UNITED STATES PATENT AND TRADEMARK OFFICE

APPLICATION NO.	FILING DATE	FIRST NAMED INVENTOR	ATTORNEY DOCKET NO.	CONFIRMATION NO.
09/786,597	02/28/2001	Kenichi Hirahara	KAM/133/PC/U	1408

Office Action Summary

DETAILED ACTION

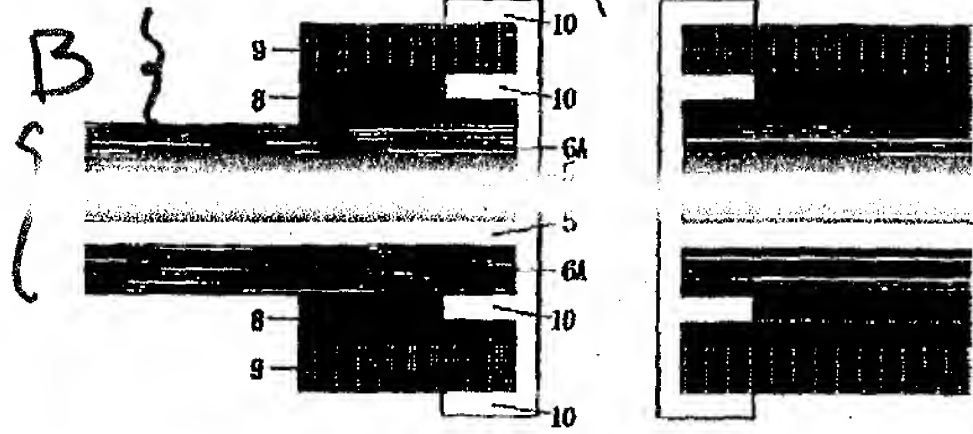
As best understood to claims 1-4, JP discloses a through hole conduction structure of a flexible multilayer circuit board (100, see an attached paper) and a method for forming a through hole conduction structure of a flexible multiplayer circuit

board as shown in figures 1-12, and also, see an attached paper on a back of an office action, comprising:

an internal layer circuit board (4, 7, 7, 5, 5, hereafter A) which being formed a cable portion; and

an external layer circuit board (8, 9, hereafter B) which being formed a component mounting portion laminated on one side or both sides of said internal layer circuit board (see figures 1-2),

wherein, said flexible multilayer circuit board having a through hole plated conduction portion (10) formed of said internal layer circuit board and said external layer circuit board,

a surface protection layer (6A, 6B), which is a cover film consisting of polyimide resin forming on an external surface of a wiring pattern (5) of said internal layer circuit board is formed in a region retreated toward the outside from a position of a through hole (11) for the through hole plated conduction portion (10).
